LONDON BOROUGH OF HILLINGDON

COMMENTS ON THE EXAMINING AUTHORITY’S SECOND WRITTEN QUESTIONS

HIGHWAYS ENGLAND'S RESPONSE

SHEET 1: Cranford Park Conservation Area and M4
Date of all pictures: 13/11/2015

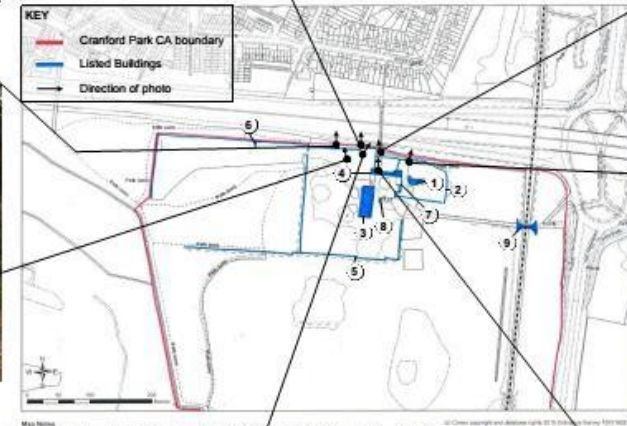
E – Visual Impact	<i>LB Hillingdon Comment</i>	Highways England Comments
<p>1. In the applicant’s response to FRQ, information is provided on the location and height of signs and gantries REP2-002, Section 4 Appendix C. Does this information assist IPs in their consideration of potential visual impact from the scheme?</p>	<p><i>The information does provide some assistance in understanding the visual impacts, however, there remains one area of concern in relation to Cranford Park.</i></p> <p><i>Following the Inspector's site visit, the London Borough of Hillingdon has provided additional visual information on the impact of the M4 Motorway on the setting of Cranford Park and its listed buildings. Sheet 1 shows the Cranford Park Conservation Area boundary, the location of the listed buildings and highlights existing viewpoints, from where traffic is already visible and considered detrimental to the setting of the historic assets. From the Cranford underpass west, the use of the hard shoulder will bring traffic closer to the buildings and the walled garden (figs 1.3- 1.6). The London Borough of Hillingdon considers that the additional low level and ineffective timber barrier should be upgraded along the boundary with the park (fig 1.6); this should be raised up to 4m in height together with additional planting. Screens should be attached to the concrete southern face of the underpass to safeguard the setting of the Stables (figs 1.0 and 1.2) and low level planting, or low screening installed along the existing barrier line of the slip road, to obscure views of the traffic currently visible from the footpath to the rear of St Dunstan's Church and the boundary of the park (fig 1.1). These are views</i></p>	<p>The comments from the London Borough of Hillingdon focus on existing views of traffic from the northern boundary of the Cranford Park Conservation Area and associated listed buildings. While Highways England accepts that the traffic on the M4 is visible from close to the boundary of the conservation area, the views of traffic are shielded from most of the Park and listed buildings due to the extensive planting in and around the Park, as shown in photomontages 40, 41 and 53 to 67 provided in Appendix A to the Response to the Examining Authority’s Second Written Questions (REP5-004).</p> <p>Highways England's assessment that the Scheme has minor adverse impacts on the conservation area and associated listed buildings is appropriate, as the relocation of traffic slightly closer to the highway boundary plus the new gantries and ERAs will not materially affect the integrity of the conservation area as a whole and only result in modest changes in landscape setting and views from restricted areas of the Park. Historic England accepted the assessment findings in the SoCG with Highways England.</p> <p>Notwithstanding the above, Highways England proposes to replace the existing wooden fence with a 2m high noise barrier. This will provide additional noise mitigation over and above that</p>

E – Visual Impact	<i>LB Hillingdon Comment</i>	Highways England Comments
	<p><i>that exist below the level of the existing tree canopy and are highly visible during the day and also at night, when the lights of the moving traffic creates an almost continuous line of illumination.</i></p> <p><i>The Council has provided additional views of the gantry positions (G1-07 and G1-08) in attached Sheet 2. These are views adjacent to the Harlington Village Conservation Area boundary and as noted in the Council's Local Impact Report. Highways England's most recent consideration of the impact of the gantries and refuge E1-A1 on views from within the extended conservation (figs 2.0- 2.3) is not supported by the Council and the view from the rear the Church of St Peter and St Paul (fig 2.4) has not been addressed by them. With regards to these locations, the Council is of the view that the impact of the works is such that it would wish to see additional shrub and tree planting provided, even if this is off site, as the proposed replacement grass seeding would do little to screen views of the new structures and areas of hard surfacing- the latter to be created directly on the boundary of the conservation area.</i></p> <p><i>Please see Appendix B for Sheet no.1 and Sheet no.2 referred to in this section.</i></p>	<p>already offered in the Environmental Statement, and visual screening of the traffic. Consequently, the setting of these heritage assets will be enhanced, in compliance with paragraphs 5.130 and 5.137 of the NN NPS.</p> <p>Highways England considers that the provision of 4m high barriers, as proposed by London Borough of Hillingdon, will create significant adverse visual impacts, which would be disproportionate, given that the Scheme will reduce traffic noise in the opening year and the change in views in traffic and motorway features is minor and restricted to a narrow fringe along the northern border.</p> <p>Further, there are important engineering considerations which need to be taken into account when considering tall barriers. The provision of 4m high barriers would require more extensive foundations than 2m high barriers in order to withstand wind load. Consideration would also need to be given to locating tall barriers further from the motorway, to avoid collision with vehicles in the event of the barrier failing structurally, through a road traffic accident or deterioration of structural components. These considerations mean that the foundation works for a 4m barrier are normally more extensive than a 2m barrier, resulting in the need to clear larger areas of vegetation and in some circumstances earthworks would be required to provide sufficient footing for the foundations. Tall barriers also result in further adverse impacts of views from the road, and</p>

E – Visual Impact	<i>LB Hillingdon Comment</i>	Highways England Comments
		<p>landscape setting and views of receptors outside the highway boundary. Highways England considers that given the lack of need for tall barriers for mitigation, the narrowness of the verge in this area, and the adverse visual effects, that 4m high barriers are not appropriate.</p> <p>Highways England does not propose to plant shrubs and trees behind the new 2m high acoustic barrier as the barrier itself, set in the context of the existing vegetated edge of Cranford Park, would not be a visually intrusive new feature.</p> <p><u>Harlington Conservation Area</u></p> <p>As noted above, it is stated in the Enhanced Noise Mitigation Study Report that Highways England is proposing a 2.5m high fence along the boundary of the Harlington Conservation Area, but is not proposing any additional planting behind the fence. The barrier itself would for the most part be barely perceptible and set in the context of existing vegetation. From locations where it would be visible i.e. in oblique views from the edge of the Conservation Area, it would form a relatively minor new element in the view and the assessment is that it would not be considered visually intrusive.</p>

SHEET 2: Harlington Conservation Area and M4
Date of all pictures: 13/11/2015

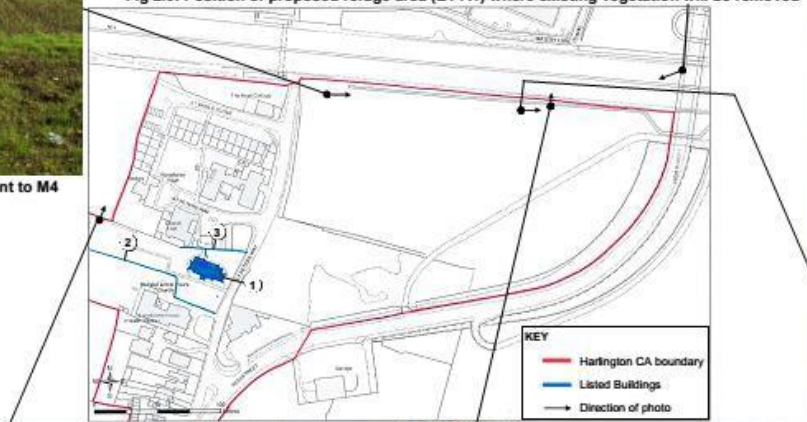
Question No	<i>LB Hillingdon Comment</i>	Highways England Comments
	<p><i>views over time.</i></p> <p><i>The filtering of views of G1-09 viewed from Harlington Village to the south could be enhanced by additional woodland planting on Council- owned land directly opposite, between St Peter's Close and the motorway.</i></p> <p><i>In addition to this, the long distance oblique views could be enhanced by providing longer stretches of woodland planting between the carriageway and the motorway boundary, for example between G1-07 and G1-11. - If this is not feasible, off-site planting to the south of the motorway boundary should be considered.</i></p> <p><i>Lower level views and the blocking of views of the source of the traffic noise could best be improved by installing acoustic fencing.</i></p> <p><i>The closest ERA's include E1-A1 (south side, west-bound) and E1-B1 (north side, east-bound). These features are relatively low-lying and could be fenced close to the edge of the ERA, with mixed woodland planting between the fence and the motorway boundary (for longer term screening).</i></p> <p><i>The approach to the pedestrian subway at the north end of St Peters Way provides uninterrupted exposure to the motorway traffic and source of traffic noise. This is a problem shared with St Dunstan's and several other pedestrian underpasses. These gaps in the fencing would benefit from the installation of acoustic barriers. The barriers could be</i></p>	<p>Hillingdon in its response:</p> <p><u>Gantry G1-03, Type 4 and 9.4m high (West Bound)</u></p> <p>This Gantry, located immediately to the east of and in the context of the Warrington Road overbridge, would not be visible from high sensitivity visual receptors resulting in a neutral visual effect.</p> <p><u>Gantry G1-07, Type 3 and 12.4m high (West Bound)</u></p> <p>Highways England agrees that Gantry G1-07 would result in a residual effect of slight adverse on views from some residential properties, as well as from the west end of the churchyard of St Peter & St Paul Church. (See Highways England's comment to the London Borough of Hillingdon's written response submitted at Deadline V (REP5-005)). At paragraph 3.16 of the SoCG with Historic England, it is agreed that no impacts to the setting of the Church of St Peter and St Paul are anticipated, and therefore no mitigation is assessed to be required.</p> <p><u>Gantry G1-08, Type 4 and 10.4m high (East Bound)</u></p> <p>This gantry is located away from high sensitivity visual receptors and is considered to have a neutral visual effect.</p> <p><u>Gantry G1-09, Type 3 and 12.8m high (East Bound)</u></p>

Question No	<i>LB Hillingdon Comment</i>	Highways England Comments
	<p><i>staggered in such a way as to close the gap so that the view is blocked while continuing to provide pedestrian access.</i></p> <p><i>It should be borne in mind that planting alone will not provide an acoustic barrier and will take years to provide a filtered visual screen, the effectiveness of which will on the species mix and width of planting.</i></p>	<p>With reference to Photomontages 30 and 31, which were submitted to the London Borough of Hillingdon on 14 September 2015, this gantry would form a barely perceptible feature in the winter view from residential properties on St Paul’s Close resulting in a slight adverse residual effect.</p> <p><u>Gantry G1-11, Type 3 and 11.7m high (West Bound)</u></p> <p>This gantry is located approximately 450m west of the Harlington Village Conservation Area and although it may potentially be seen in some long distance views from the west edge of the Conservation Area, when seen in the context of intervening elements and the urban skyline beyond, it would form a barely perceptible feature in the view.</p> <p>Highways England notes that the London Borough of Hillingdon describes the Emergency Refuge Areas (“ERAs”) as “relatively low lying”. Highways England considers that the ERAs would be relatively inconspicuous features and would be used by vehicles very occasionally. The two ERAs are located away from high sensitivity visual receptors and so their presence and occasional usage is considered to have a neutral visual effect.</p> <p>Highways England confirms that the northern end of Harlington Village at St Peter’s Subway was assessed as part of the enhanced noise mitigation study. Based on the results of the</p>

Question No	<i>LB Hillingdon Comment</i>	Highways England Comments
		<p>enhanced noise mitigation study (Ref 514451-MUH-00-ZZ-RP-EN-400158) (REP5-002), Highways England proposes to provide a new 323m long, 2.5m high noise barrier at St. Paul's Close, Harlington, as detailed on Sheet 15 of Appendix E to the Enhanced Noise Mitigation Study Report. The provision of this mitigation will provide further noise decreases to properties in Harlington, in addition to the negligible to minor noise decreases on Scheme opening (without enhanced mitigation) presented on Sheet 15 of Drawing 12.4 of the ES (Application Document Reference 6-2, APP-268).</p> <p>The new barrier will help to screen most traffic other than high sided vehicles in a number of views out of the Harlington Village Conservation Area. Therefore, Highways England's preference, when considering the context of its vegetated setting, is to use a timber barrier, which would provide an additional visual benefit in some views from Harlington Village Conservation Area and its setting, as well as reducing M4 traffic noise within parts of it.</p> <p>Given the visual effects described above, Highways England does not consider it proportionate or necessary to provide further mitigation through the provision of screen fencing or off-site planting to further mitigate the visual effects of the Scheme.</p> <p>Highways England recognises that planting</p>

Question No	<i>LB Hillingdon Comment</i>	Highways England Comments
		<p>does not provide acoustic screening. In relation to visual screening, Highways England considers (based on its experience of other road schemes) that new tree planting using native species to the locality, and which is greater than 10m in width (Design Manual for Roads and Bridges (“DMRB”), Volume 10 Good Roads Guide, HA56/92), can take up to 15 years before it can perform as an adequate visual screen, particularly in summer when the vegetation is in full leaf. Visual screening in winter will depend on the amount of evergreen plants in the mix and the depth of the planting. Usually evergreen species comprise between 15 and 25% of the overall species mix. DMRB does not provide any advice on the depth of planting for a winter screen, but this would have to be in excess of 10m, otherwise there would be filtered winter views through the winter canopy.</p>
